KTN WOOD ROAD CULVERT REPLACEMENT AK122

PROJECT NO. 0003212/SFHWHY00098

Asbuilt 8/3/2022
2nd Version

1 CULVERT SECTION P-1
 E1 SCALE: NOT TO SCALE

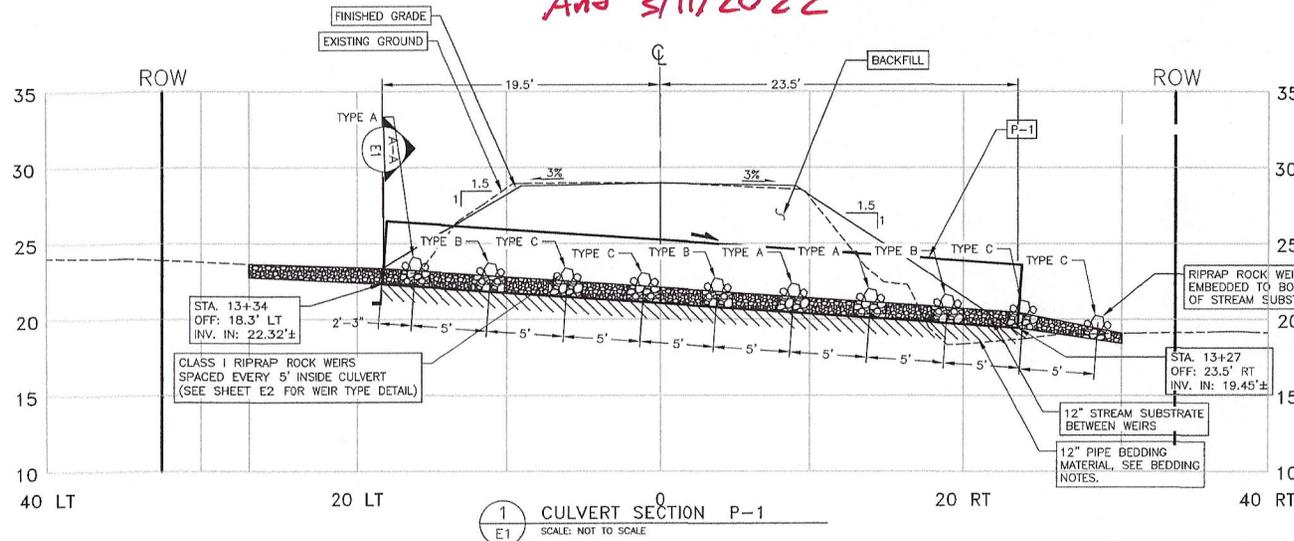
See Attached Email dated 3/8/2022 from Bob Trousil for Corrective work on weirs And 3/11/2022

1 ROCK WEIR PROFILE VIEW (TYPE A)
 E2 SCALE: NOT TO SCALE

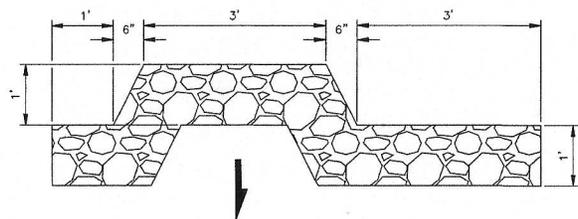
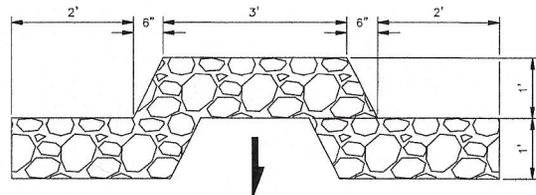
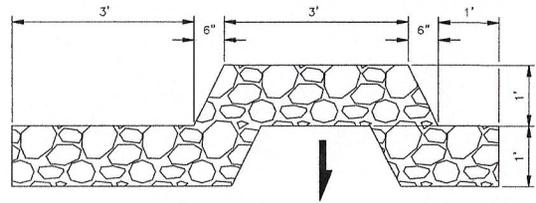
See Attached
 Email dated
 3/8/2022 From
 Bob Travis!
 For Corrective
 Work on
 Weirs

And 3/11/2022

"D" LINE PROFILE ALONG CENTERLINE (STA 10+20 TO 11+20)

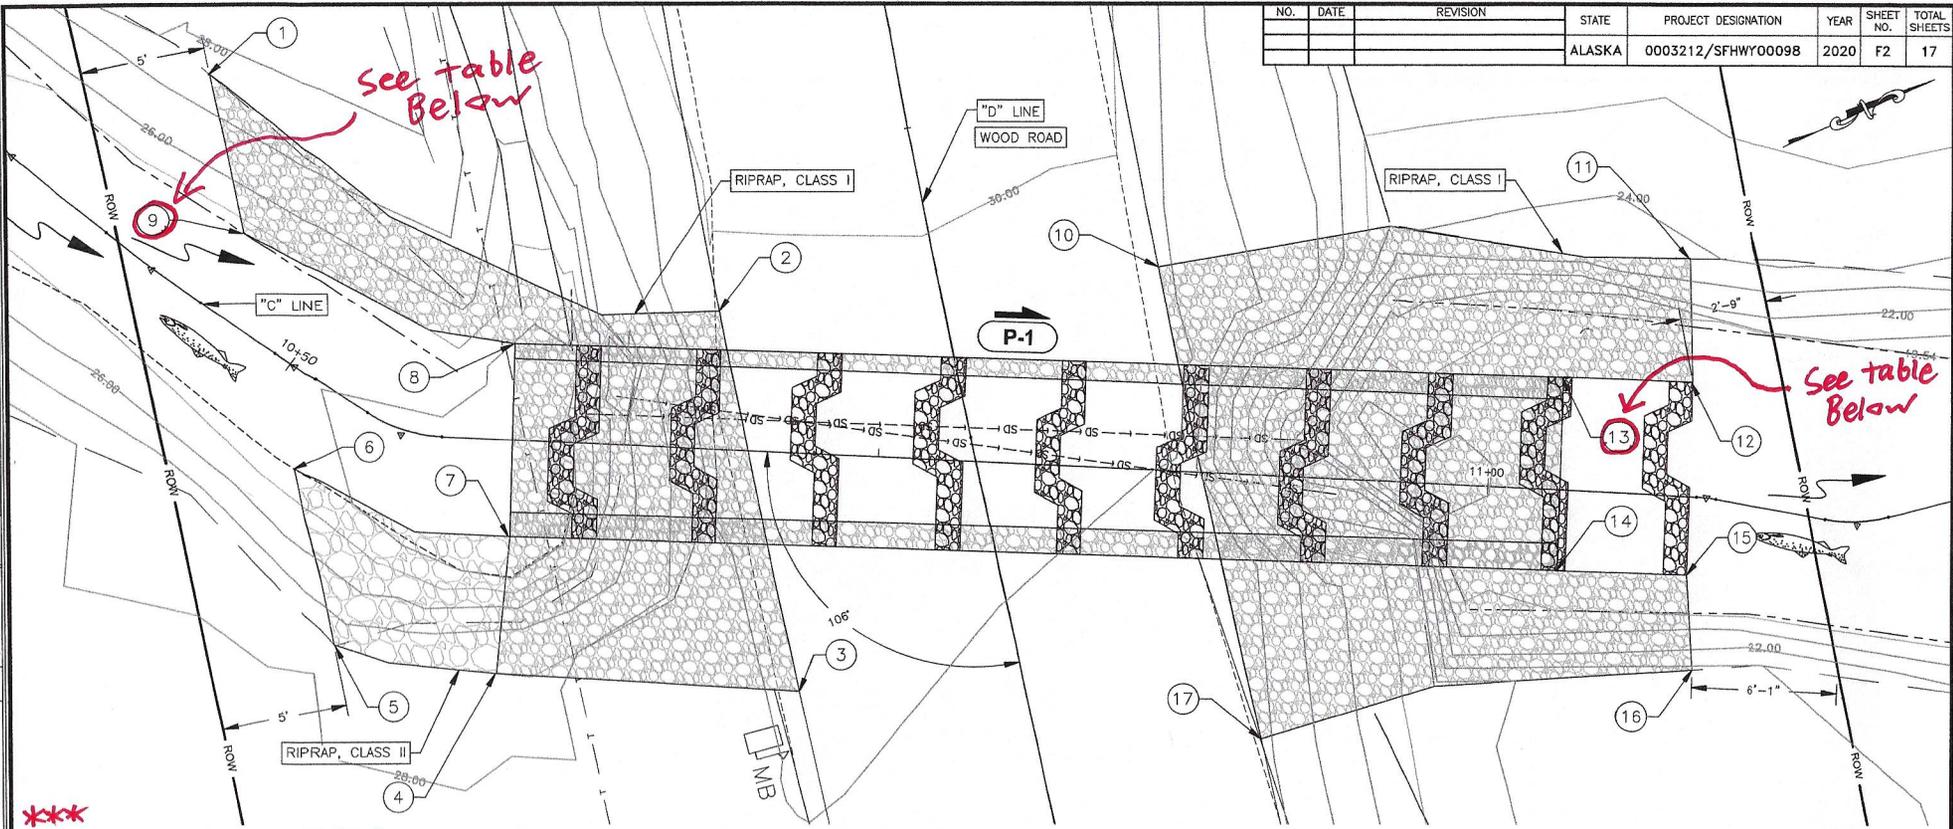
See Photos 3/9/2022 for
 Larger Riprap placed at
 Inlet End for Corrective
 Work + Scour Repair

ESCP NOT SEALED IN ACCORDANCE WITH ALASKA HIGHWAY PRECONSTRUCTION MANUAL SECTION 1120.7.3 DATED NOVEMBER 15, 2013	STATE OF ALASKA DEPARTMENT OF TRANSPORTATION AND PUBLIC FACILITIES KTN WOOD ROAD CULVERT REPLACEMENT AK122 EROSION SEDIMENT CONTROL PLAN
---	--

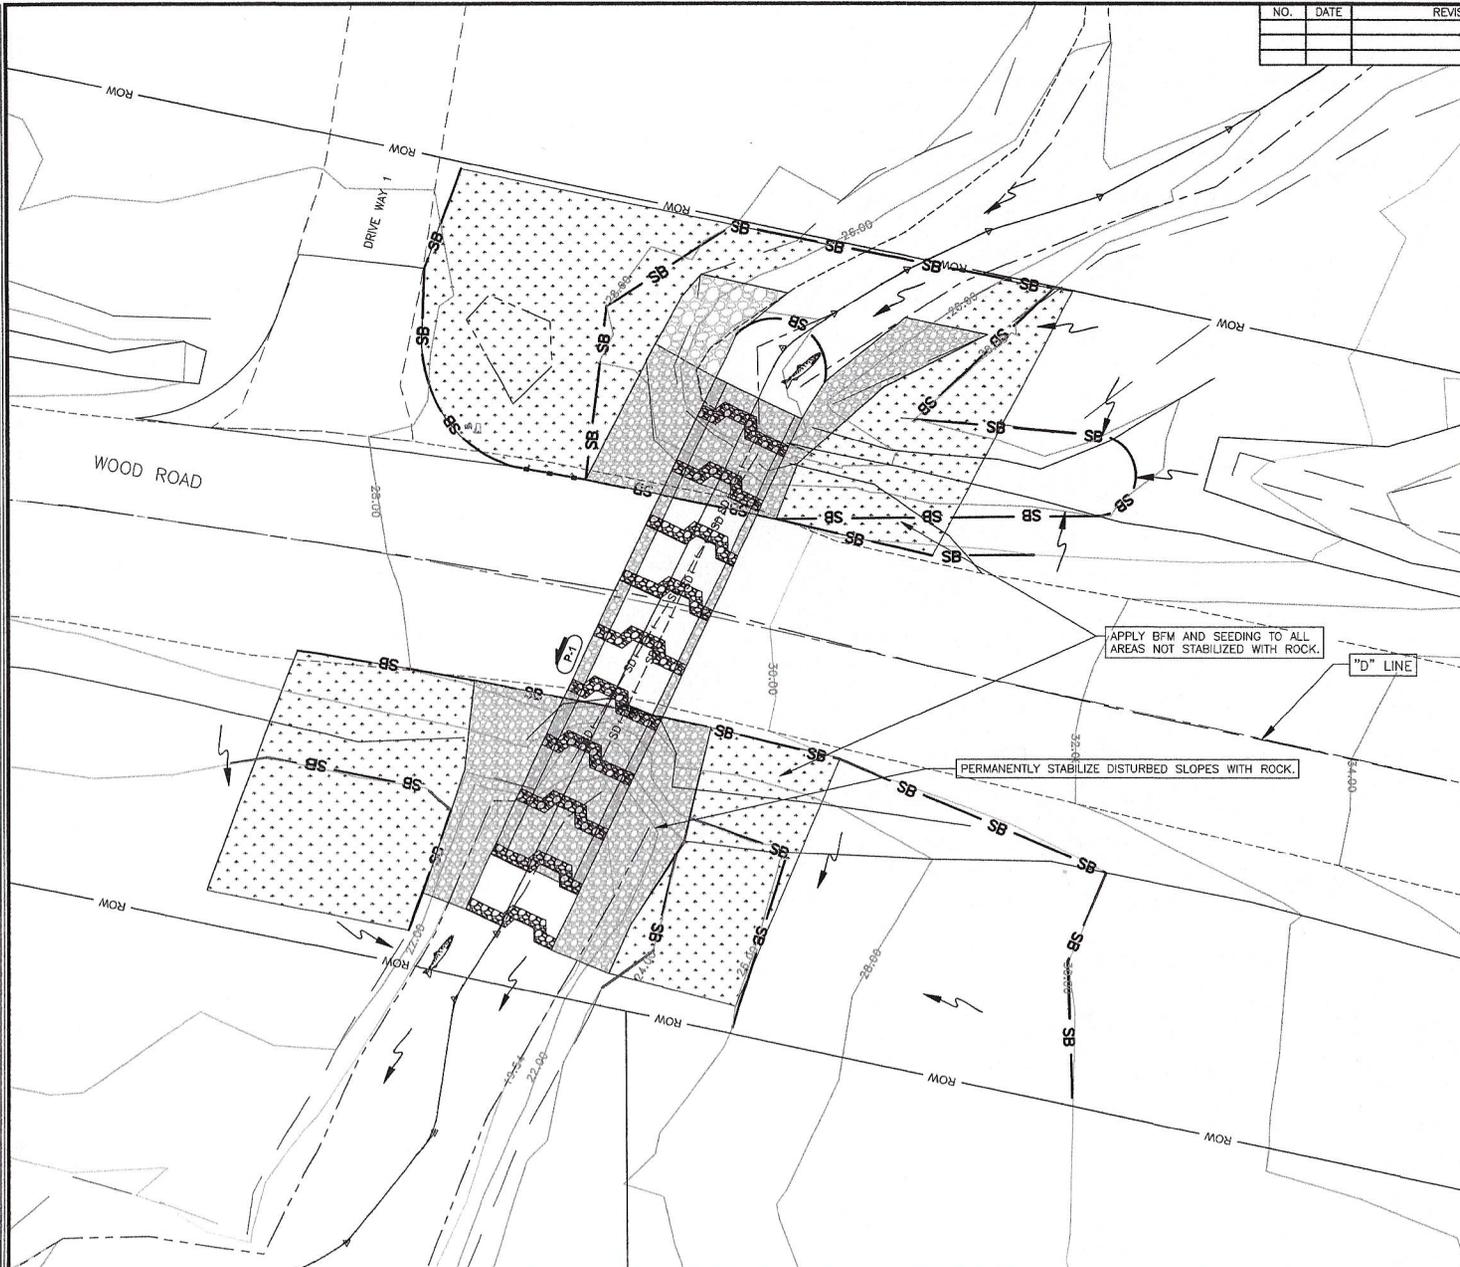
CO #2 replaces Seed, BFM, Topsoil w/ Rock Slope Armor

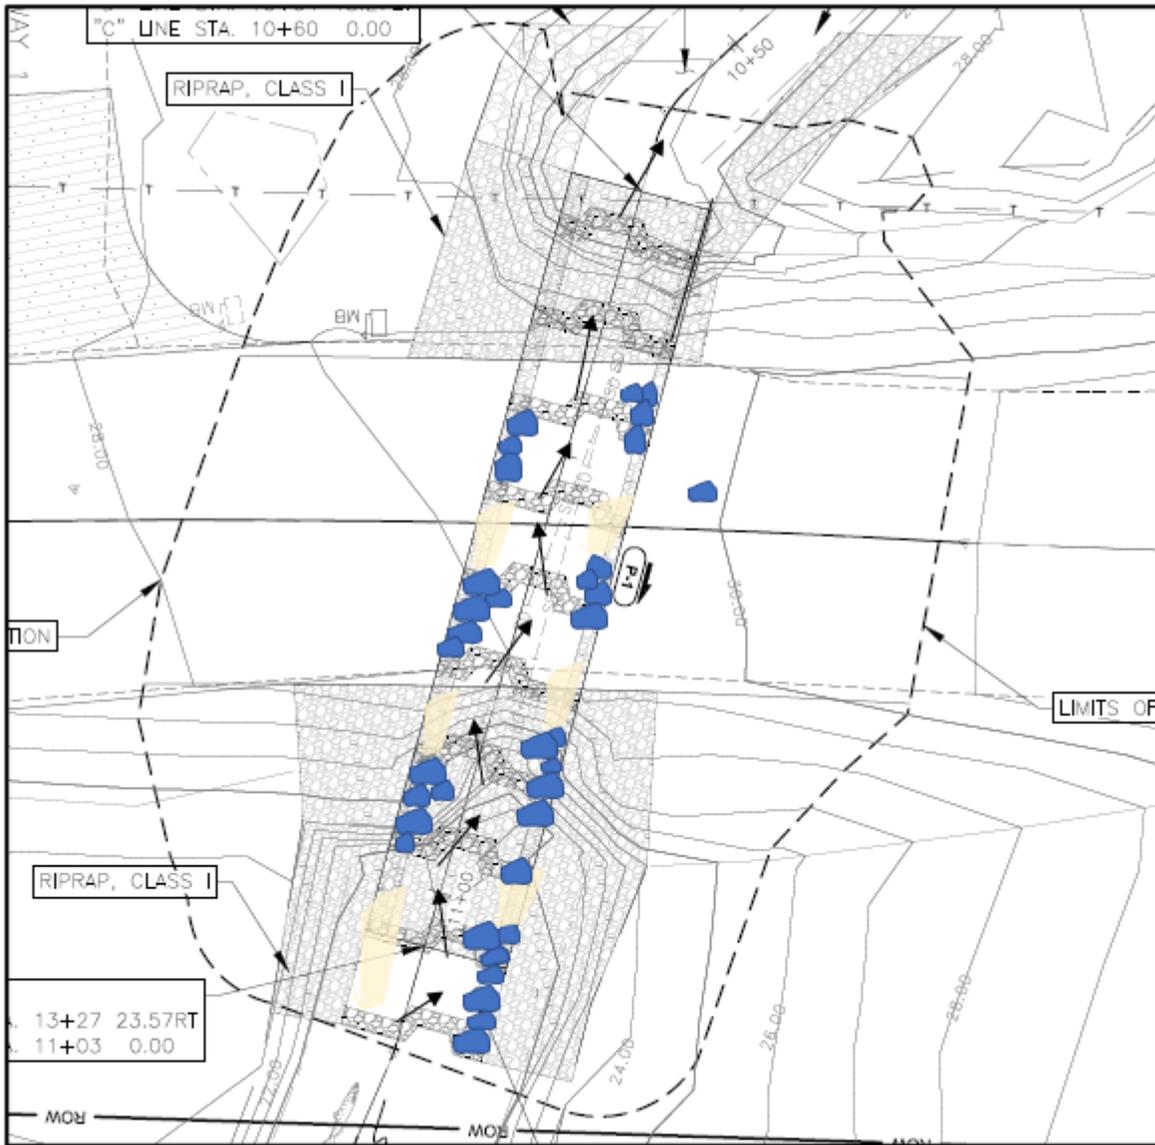
Since I won't be there tomorrow during the day, here is a concept drawing of what I think will work best in placing the stockpiled rock materials. Ignore the weirs that are shown in the drawing. Rocks, in dark blue, are schematically shown and not meant to necessarily represent individual rocks but rather rock clusters. Here is a bulleted list things to do:

1. Place the largest rocks at the intake-end to support and cover the exposed footer. Alternate these rock clusters from side to side with the larger rocks in the pattern shown.
2. Use smaller rocks to fill scour holes and shore up the side walls of the pipe as you progress downstream.
3. Place smallest rock in the areas shown in tan.
4. Basically, looking to create protrusions, forcing water flow "side to side" through the pipe.
5. From the photos, I don't believe I would do much, if anything, in the last 15 feet of the pipe.
6. There is no need to remove or rearrange any materials/rocks that are currently in place in the pipe.
7. Arrows (→) indicate anticipated flow path(s).
8. If you have "fines" I would use them as filler in the tan areas.

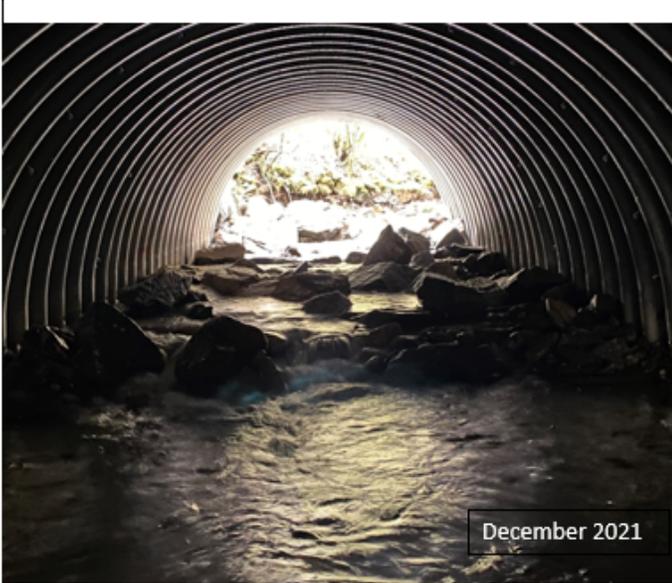
In asked Patty to send me pictures. Here are the two that are the most informative:

It appears that rock placed on the left side of the pipe in December, near the entrance of the pipe, has migrated and filled the scour pool shown in the foreground of the December shot. The footer is again exposed. That side just gets hammered because of the orientation of the stream at the entrance.

But I do like the way the materials have adjusted in the pipe over the winter. However, more, large rock is needed to support and bury the footer as shown, and any other place along the side of the pipe that would be vulnerable to high flows.

My recommendation is that we build up the left side near the intake with large rocks, which will send flow back to the other side of the pipe. Then need to consider armoring the right side of the pipe as well. Then again the left side...etc. Basically building vanes structures, forcing flows from one side of the pipe to the other. Hydraulically, its not very efficient. But, for fish passage it would be much better.

That said, the “vane” approach might be a better solution than the weirs. The flow path distance from the discharge to the intake would be increased by about 13 feet, which means the effective stream gradient is reduced from 6.7% to 5.1%. The culvert remains at 6.7% of course.

Figure 1. Schematic of placed rock and fine materials. Note: weirs shown in drawing should be ignored.

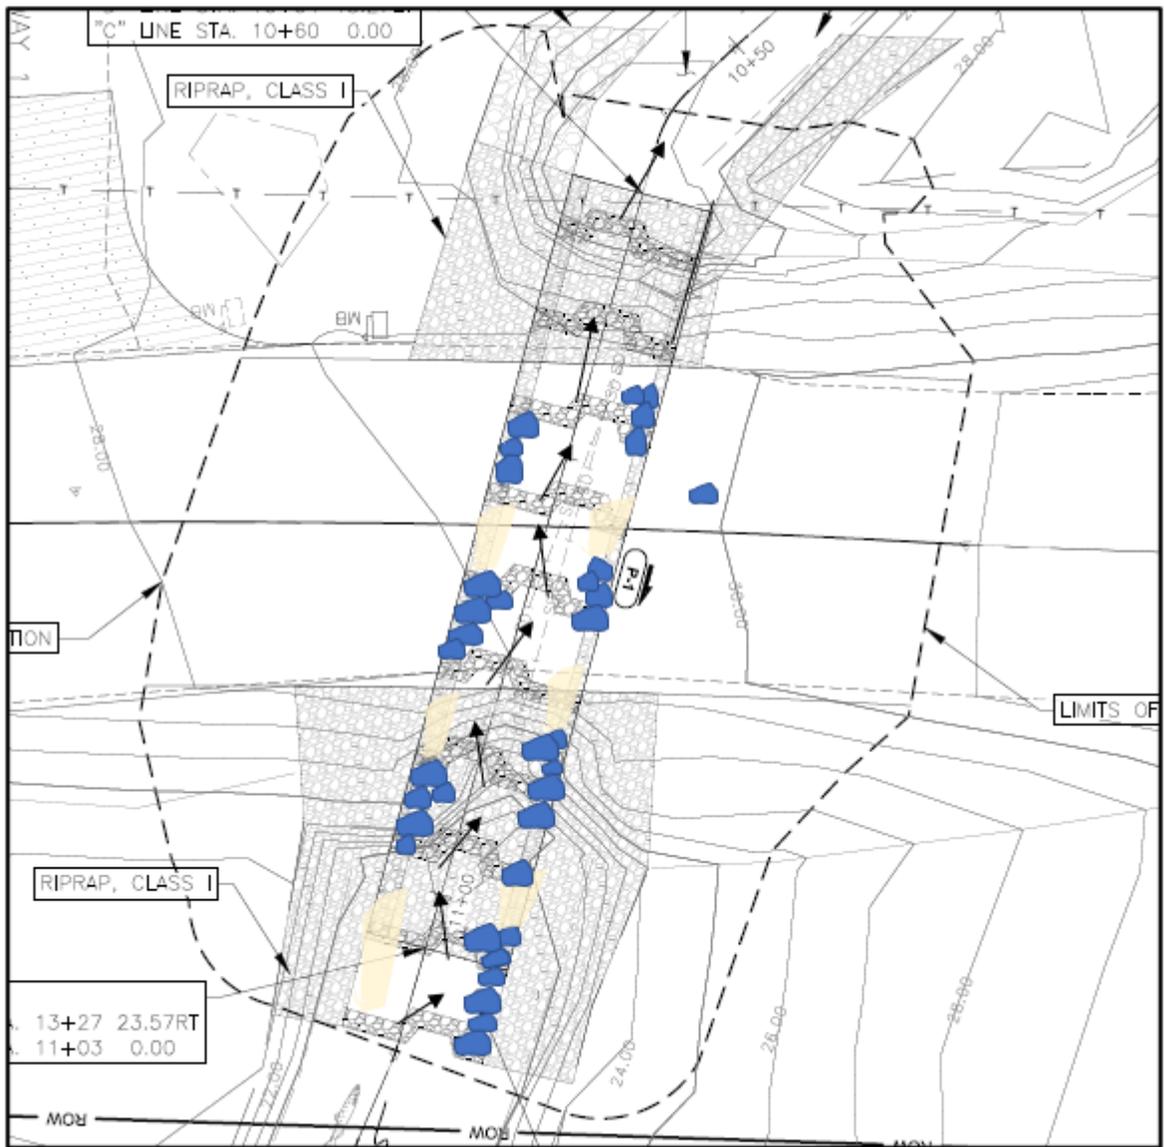
Due to the expedited nature of the work, I was unable to be onsite Wednesday. Rocks, in dark blue, are schematically shown in figure 1 and not meant to necessarily represent individual rocks but rather rock clusters. A drawing indicates the nature of the work required, which is summarized as follows:

1. Place the largest rocks at the intake-end to support and cover the exposed footer. Alternate these rock clusters from side to side with the larger rocks in the pattern shown.
2. Use smaller rocks to fill scour holes and shore up the side walls of the pipe as you progress downstream.
3. Place smallest rock in the areas shown in tan.
4. Basically, looking to create protrusions, forcing water flow "side to side" through the pipe.
5. From the photos, I don't believe I would do much, if anything, in the last 15 feet of the pipe.
6. There is no need to remove or rearrange any materials/rocks that are currently in place in the pipe.
7. Arrows () indicate anticipated flow path(s).
8. If you have "fines" I would use them as filler in the tan areas.
